**DRAINAGE LETTER**  
**FOR THE**  
**STOCKPILE GRADING PLAN**  
**FOR**  
**CLEARWAY, LOT 5**  
**EL PASO COUNTY, COLORADO**

AUGUST 2022

PCD Project No. PPR-2234

Add PCD File No.  
CDR2214

**CLEARWAY, LOT 5**  
**PROPOSED DRAINAGE MAP**

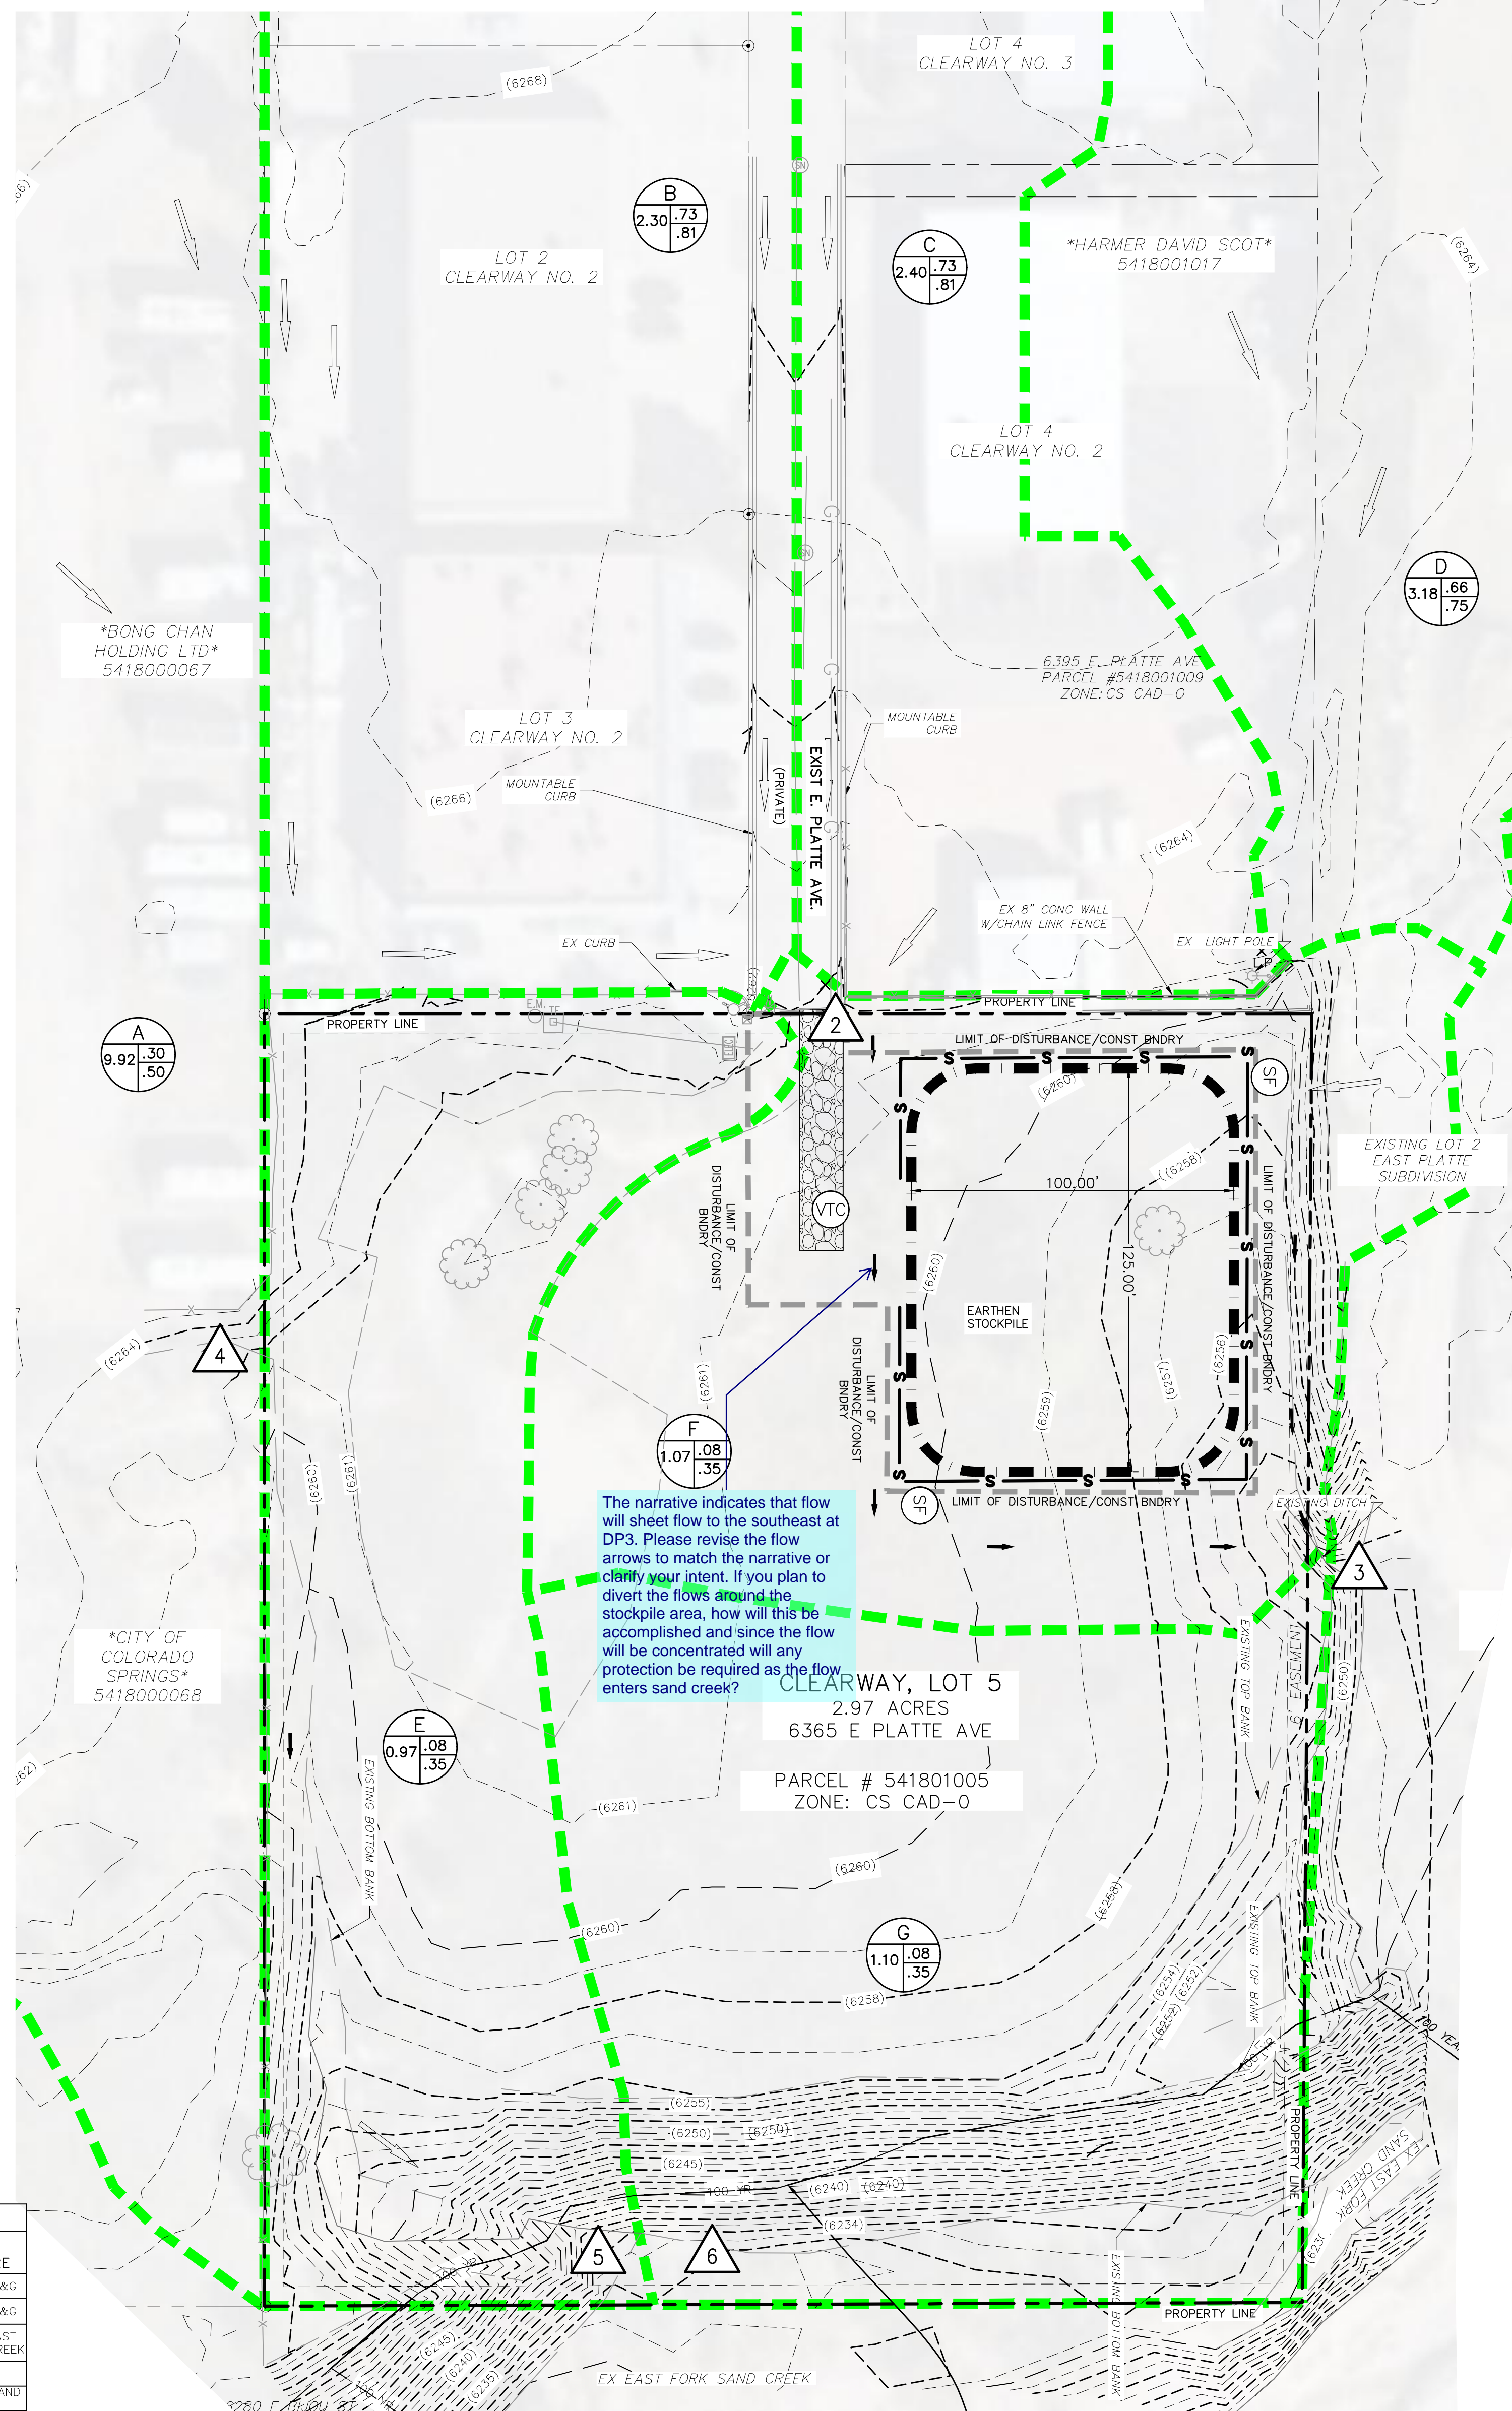
The narrative indicates that flow will sheet flow to the southeast at DP3. Please revise the flow arrows to match the narrative or clarify your intent. If you plan to divert the flows around the stockpile area, how will this be accomplished and since the flow will be concentrated will any protection be required as the flow enters sand creek?
